AL126 Series

High Dispersion Narrow Bar Lights

Change Notice

PCN No: 144

PCN_124_AL126

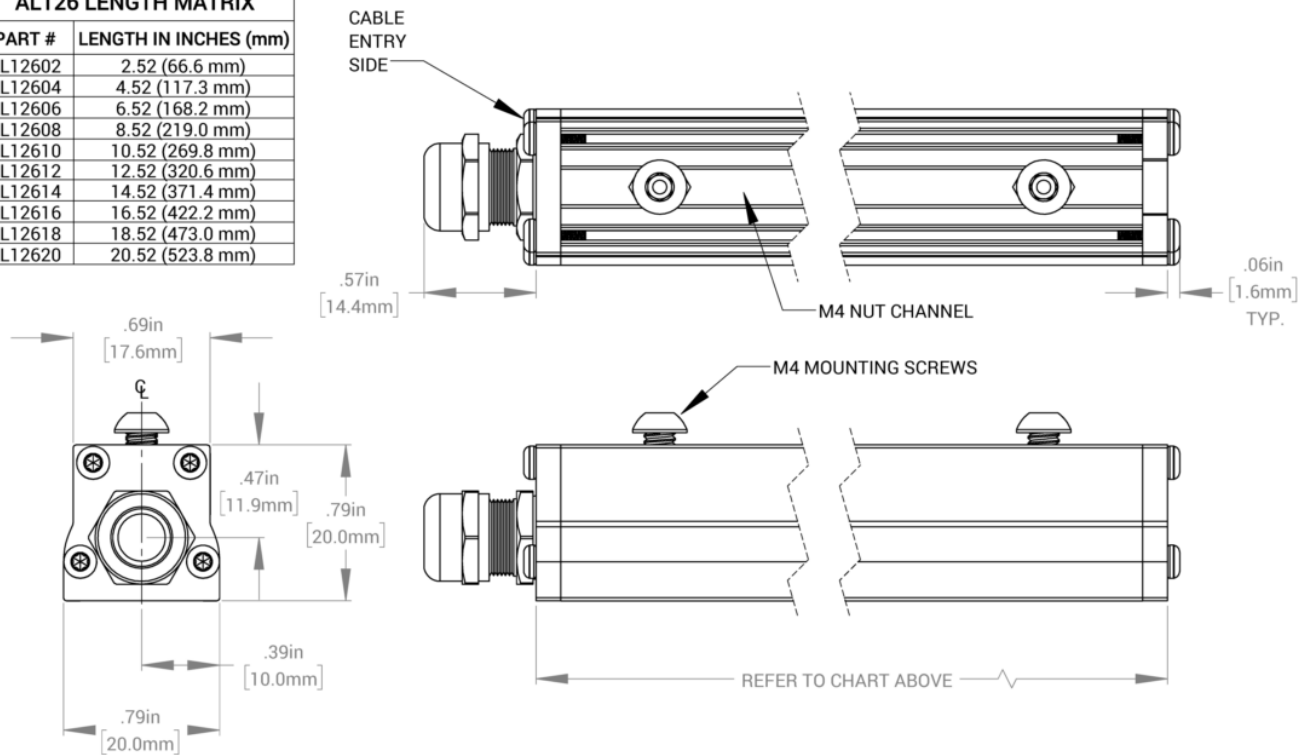
In an effort to improve our products, Advanced illumination (Ai) will update the LEDs used in the AL126 design. This change will result in a brighter, more uniform light at the same price*. Customers may still buy the current revision of this model until September 16th of 2016. After that time, orders for these products will be converted to their respective AL126 Revision A models.

This LED change will result in additional wavelengths being available: 365nm, 375nm, 385nm, 395nm, 405nm, 455nm, 530nm, 590nm, 730nm, 850nm and 940nm. Additionally the white LED color temperture will be changing from 6100K to 5000K.

*Visable and IR wavelengths that did not exist will prior will be sold at the same list price as the original colors. UV wavelengths (365nm, 375nm, 385nm, 395nm & 405nm) will be sold at a higher price that will be released at the time of product introduction.

Orders for customized (dash numbers) versions of AL126 will be honored until January 27th of 2017. Ai will be actively working with customers for those products to simplify the transition.
